# DESIGN DRAWINGS

*Oregon Square*

*Updated: September 14, 2015*

# COMMENTS TO ADDRESS - POST DR I

ENTRY GATES : PEOPLE’S GATE (SOUTH)

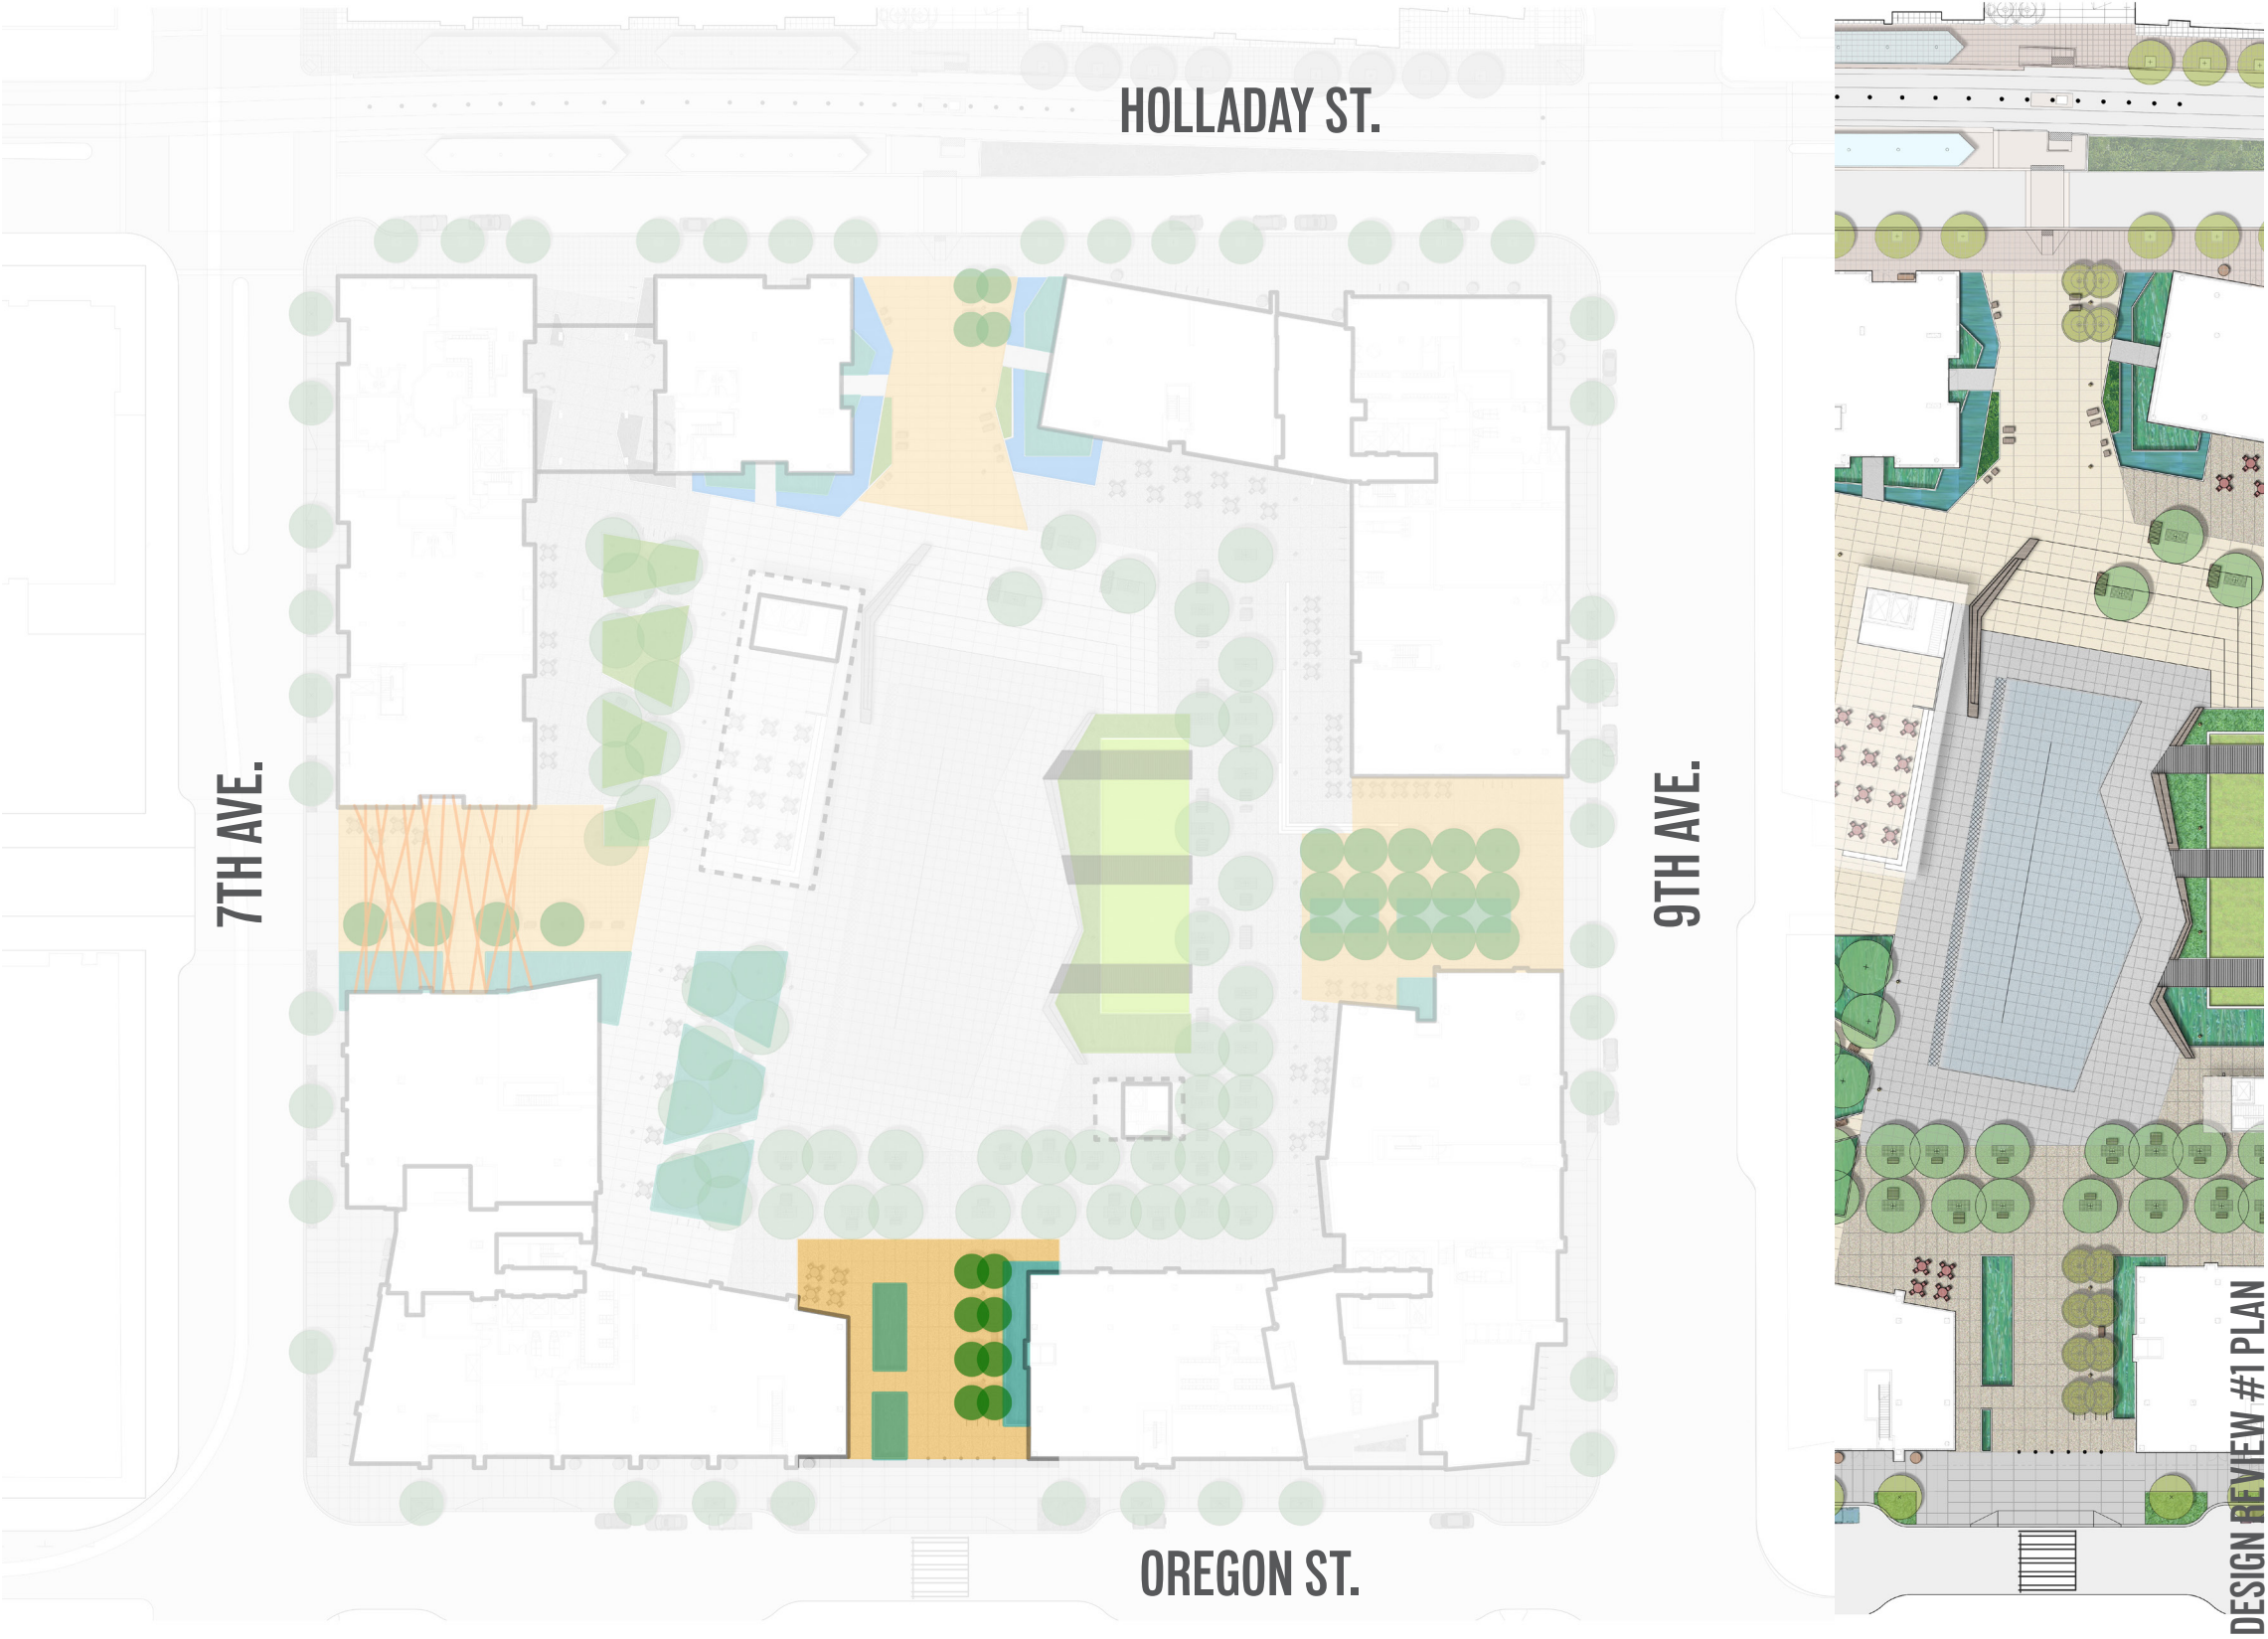
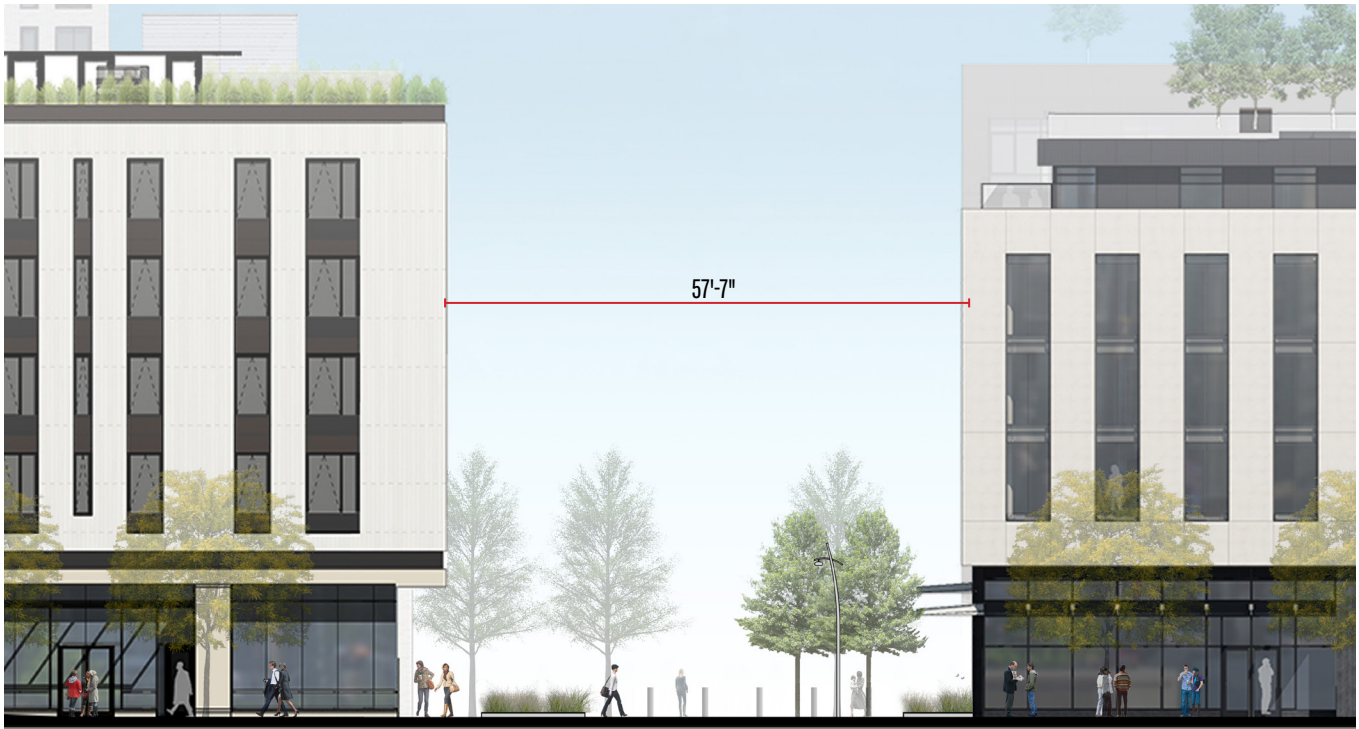
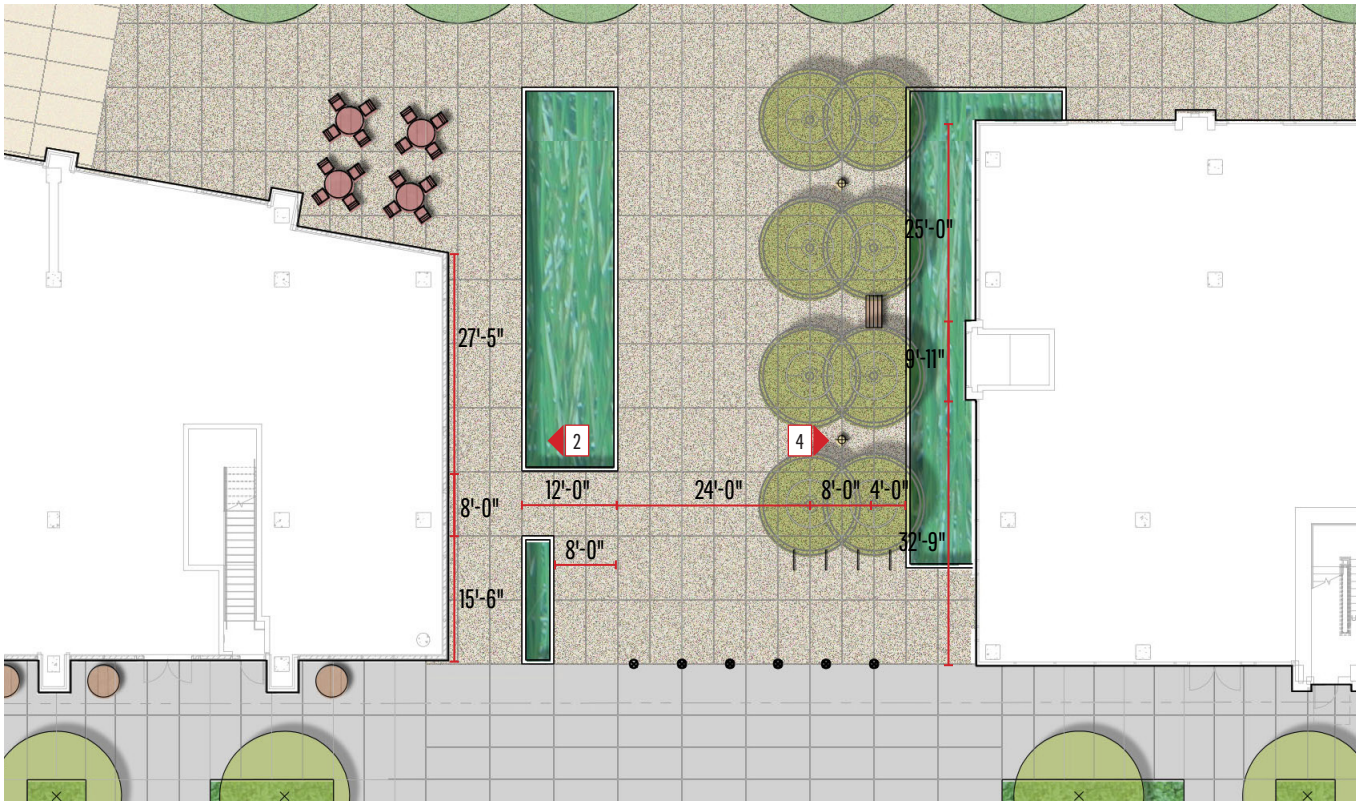
*Critical that building corners/portal edges are active and visible from streets*

THE ADJUSTMENT ON THE SOUTH GATE USES A VARIANT ARRANGEMENT OF THE SAME ELEMENTS -STORM WATER PLANTERS, TREES AND FURNISHINGS- INCORPORATING A MORE PEDESTRIAN SCALE WHILE ALLOWING FOR SERVICE VEHICLE ACCESS.

THE STORM WATER PLANTERS ON THE WEST SIDE ARE NOW DETACHED, ALLOWING FOR DIRECT ACCESS TO THE BUILDING RETAIL FRONT AND CORNERS.

THE DESIGN OF THE STORM WATER PLANTERS HAS ALSO BEEN SIMPLIFIED IN ITS LINES.
